TENANT IMPROVEMENT PLAN CHECK COMMENTS

PLAN CHECK NO:	10174233	
PROJECT ADDRESS:	1400 S Village Way	
PLAN CHECK ENGINEER:	Ahangian, Kathy	TEL: 714 647-5812
		FAX: 714 647-5897
TYPE OF CONSTRUCTION:	III B, SPK	
OCCUPANCY CLASSIFICATION(S):	M, S1	
PLAN CHECK DATES:		REMARKS/RECHECK ITEMS:
APPLICATION	1/26/2012	
INITIAL REVIEW	2/4/2012	
EXPIRATION	7/24/2012	
RECHECKS:	1. 2-27-2012	PROJECT APPLICANT CONTACT PERSON:
	2.	Bob Pinault
	3.	TEL: (714)632-9441
VALUATION:	\$25,000.00	FAX:
FLOOD ZONE:	X-0602320277J	EMAIL: bob@rdpinaultcompany.com

BUILDING "H" TENANT IMPROVEMENT FOR Habitat for Humanity

SHEET
A2.1

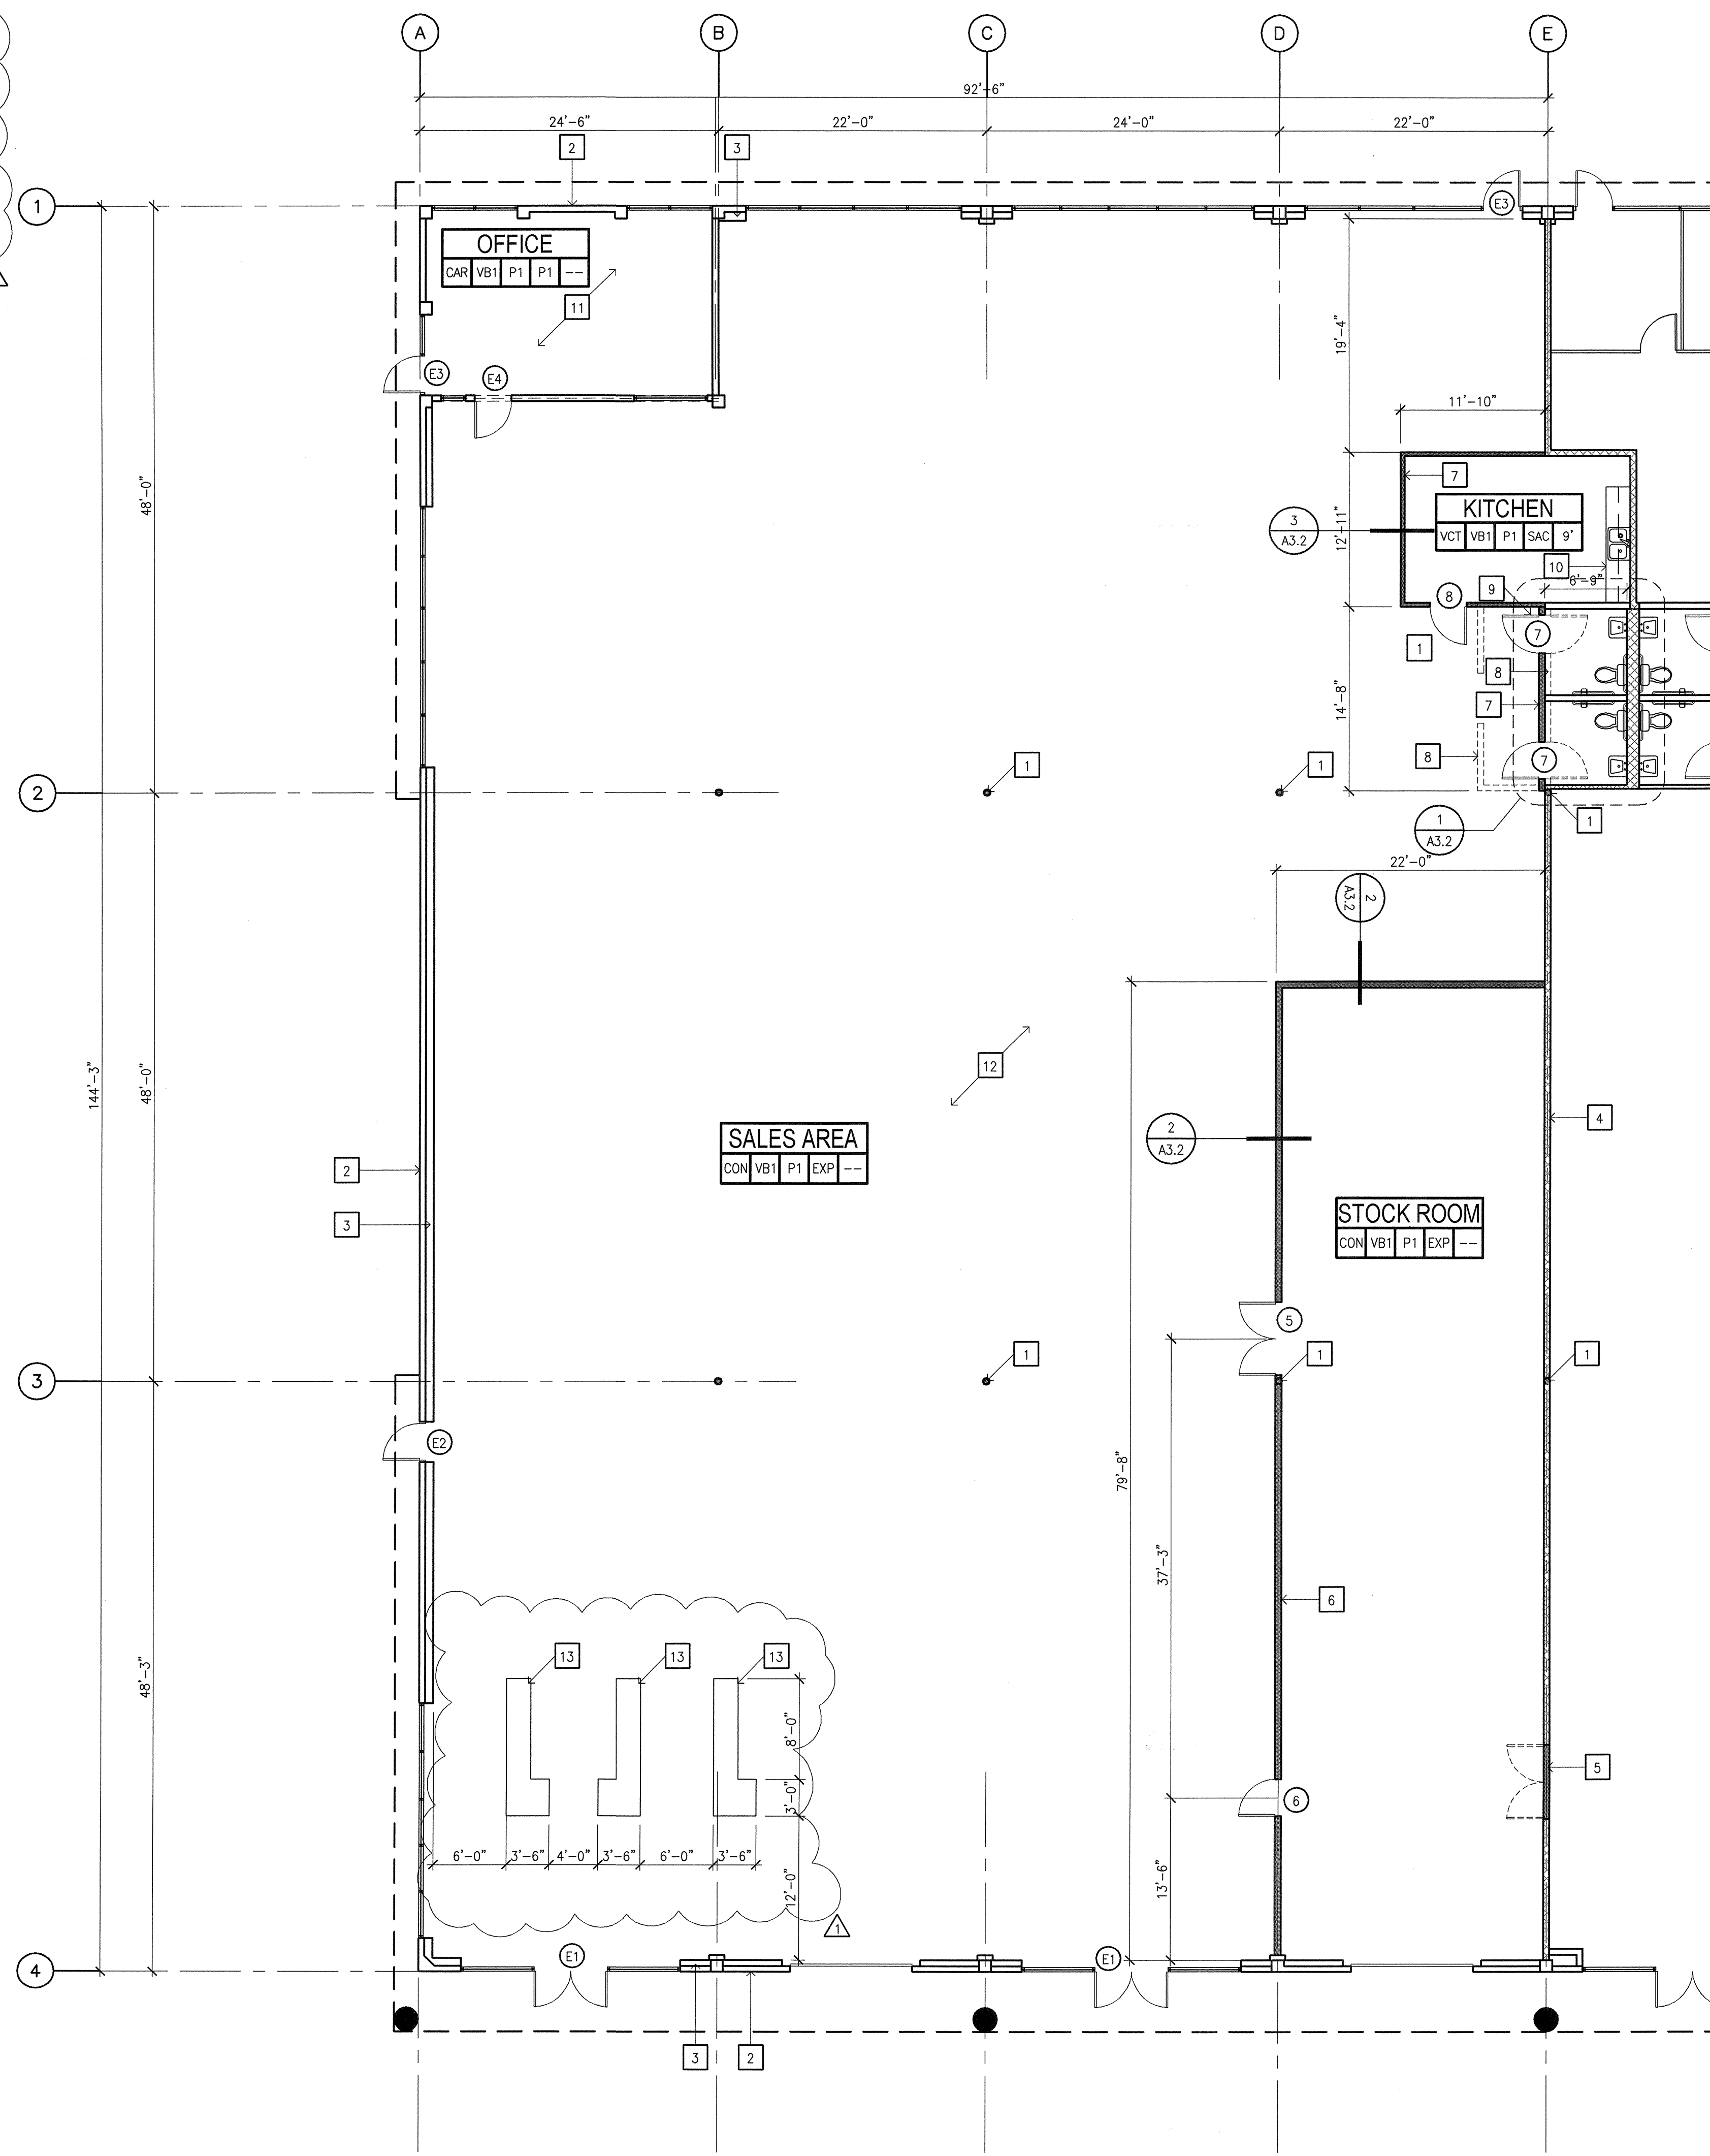
12. Provide complying exiting plan for the "reminder" area (adjacent unit) Note the use of adjacent units.

13. Provide info to show type of material and items are being stored in the stock room.

14. Verify if the kitchen sink is new or existing , if new show it is in compliance with H/C accessibility.

15. CBC Section 1110B.1.3, Check Stands CBC Table 11B-2:

- In new and existing construction, accessible check stands shall provide a clear checkout aisle width of 36" with a maximum adjoining counter height not exceeding 38" above the finish floor.
- The top of the counter lip shall not exceed 40" above the finish floor.
- Accessible check stands shall always be open to customers with disabilities and shall be identified by a sign clearly visible to those in wheelchairs. The sign shall display the international symbol of accessibility in white on a blue background and shall state "This check stand to be open at all times for customers with disabilities."

February 16, 2012
 To: Santa Ana Planning and Building Department
 From: Mack Kessels, Senior Vice President
 Subject: 1400 S. Village Way
 Habitat for Humanity of Orange County Inc. will be staging and storing new and used "for sale" general household goods to be sold within the building in the same manner as other similar floor improvement stores such as Lowe's and Home Depot retail outlets. Including but not limited to appliances, furniture, hardware, etc. There will be very limited amounts of flammable liquids in addition to other general household goods.

- 11 EXISTING AREA TO REMAIN
- 12 EXISTING EXPOSED CONCRETE FLOOR. BEAD BLAST AND SEAL
- 13 NEW POINT OF SALE CHECKOUT COUNTER W/ 38" HIGH MAXIMUM COUNTER HT. PROVIDE SIGN AT CHECKOUT COUNTER WITH INTERNATIONAL SYMBOL OF ACCESSIBILITY IN WHITE ON A BLUE BACKGROUND STATING "THIS CHECK STAND TO BE OPEN ALL ALL TIMES FOR CUSTOMERS WITH DISABILITIES"

A2.2

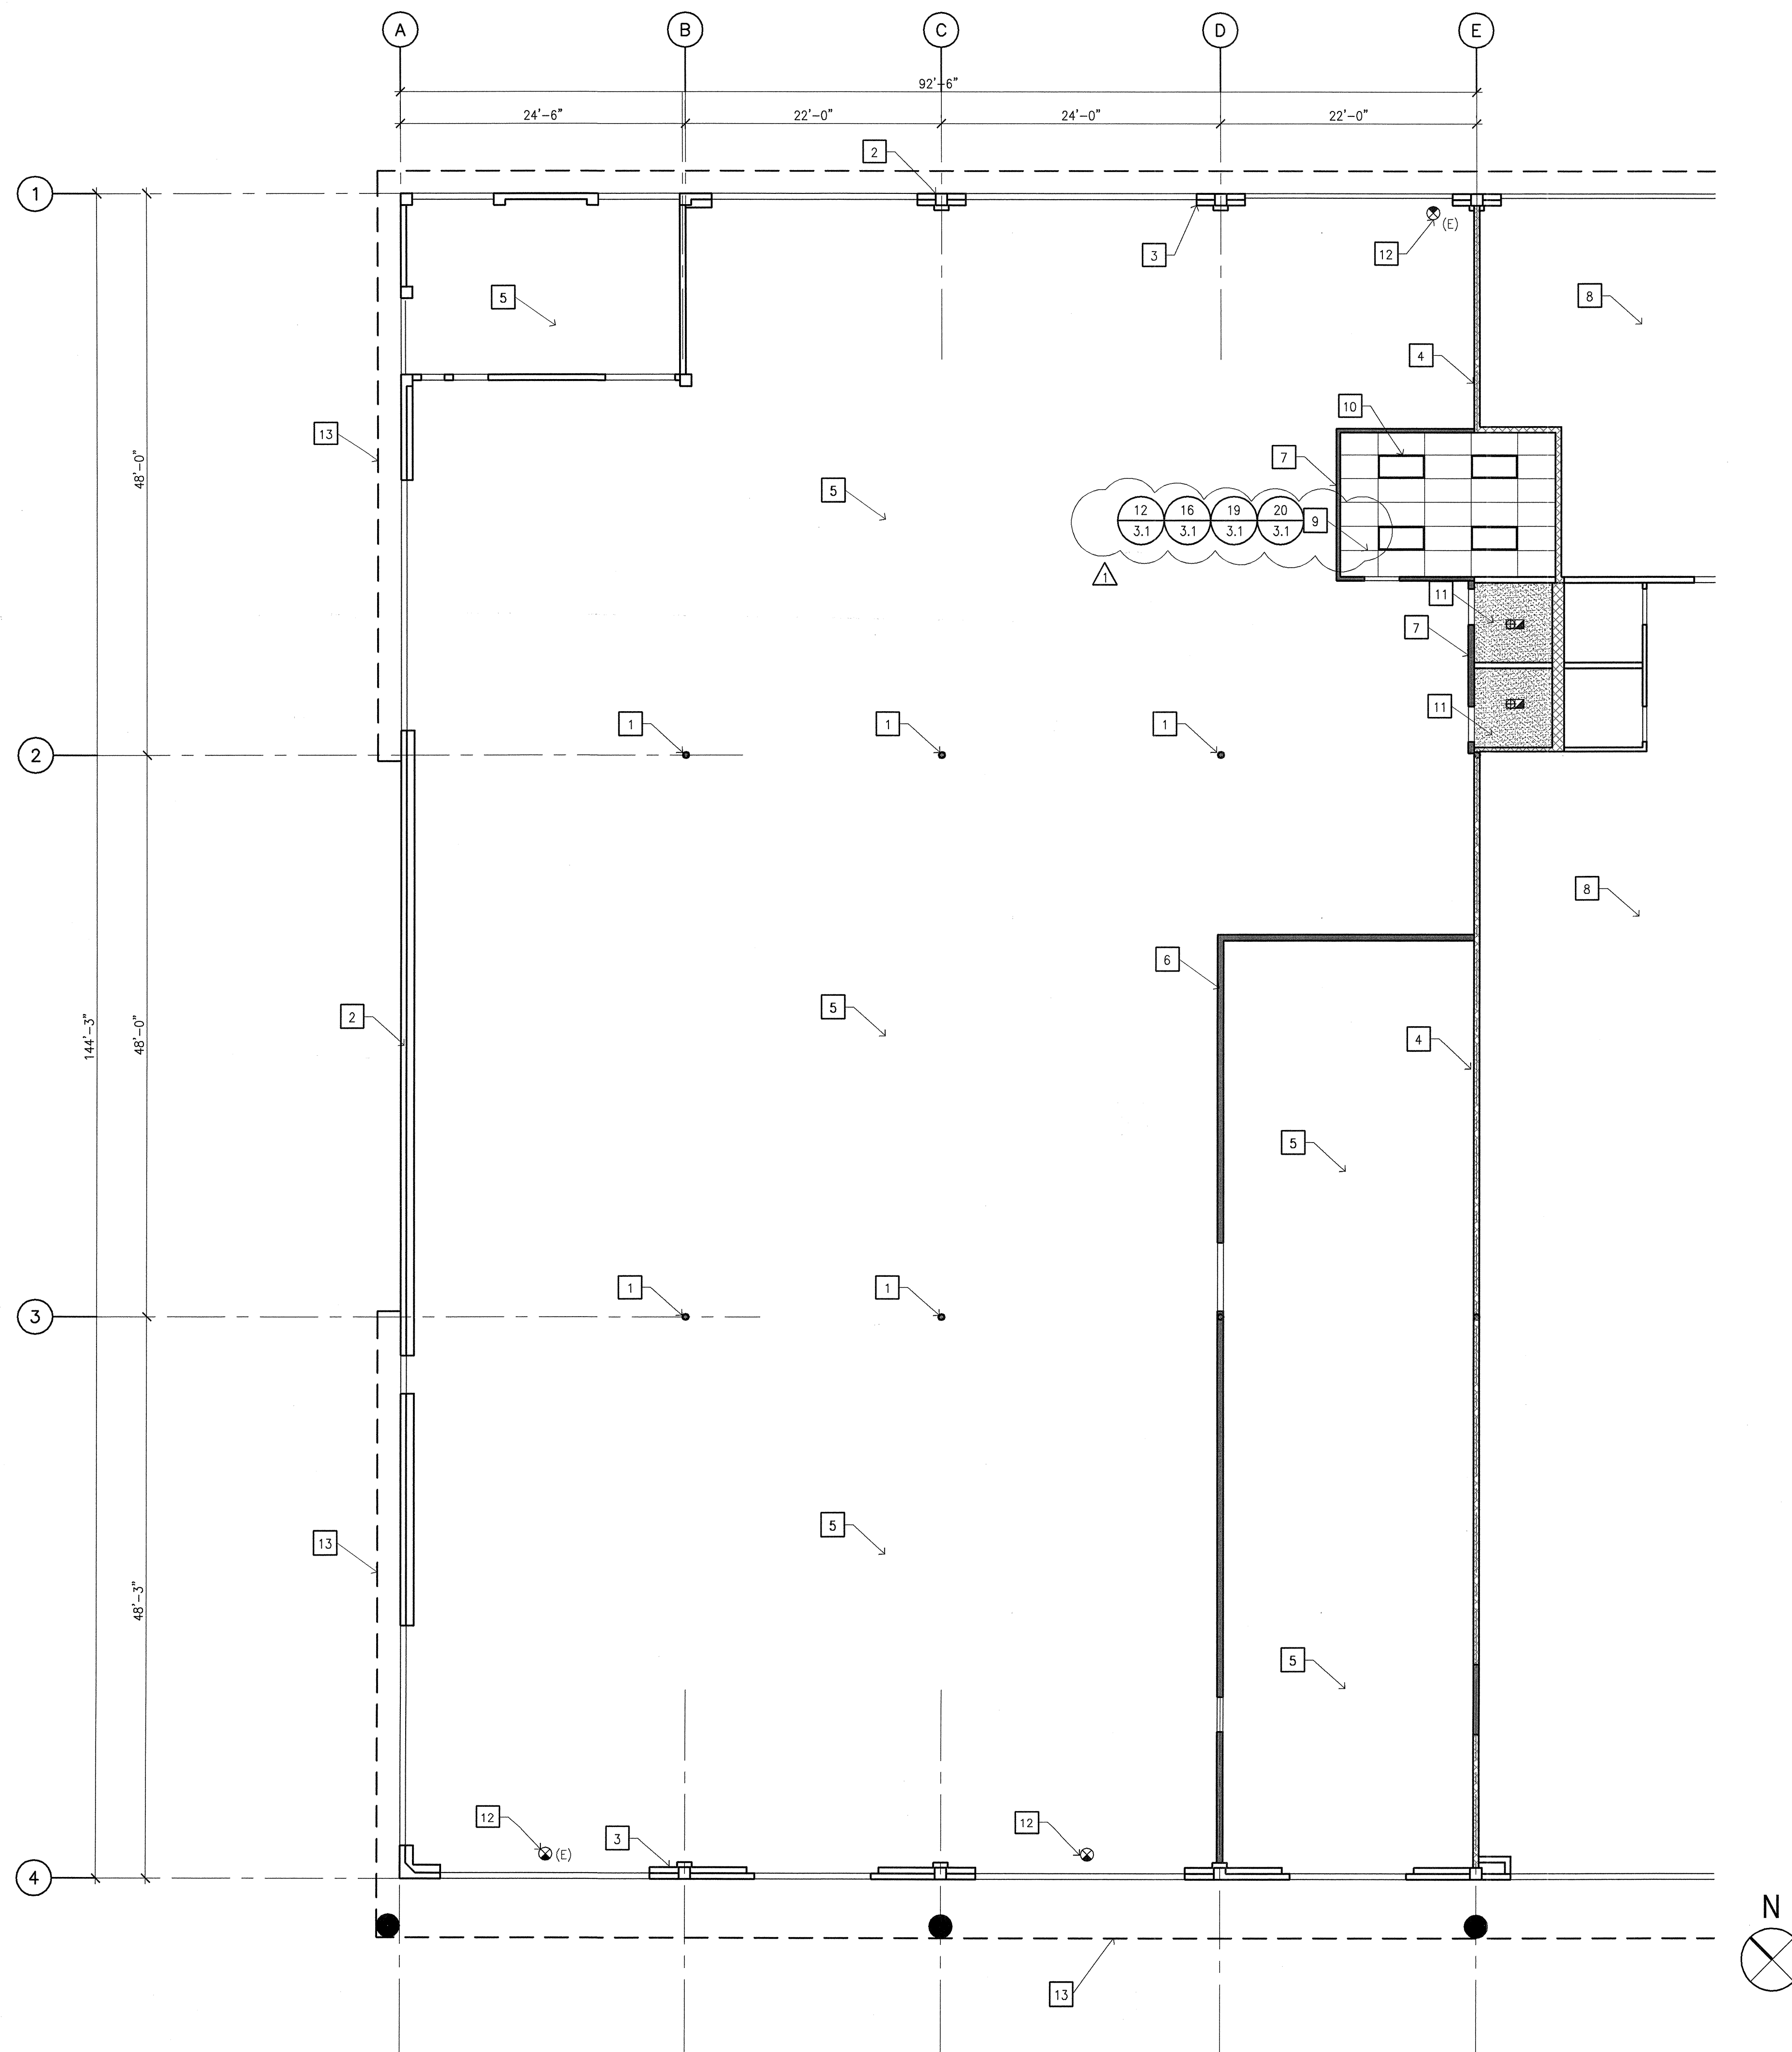
16. The reflected ceiling plan and details must show compliance with CBC Sections 711.3.1, 803, 1613, and 1705 (special inspection) for suspended ceiling systems.
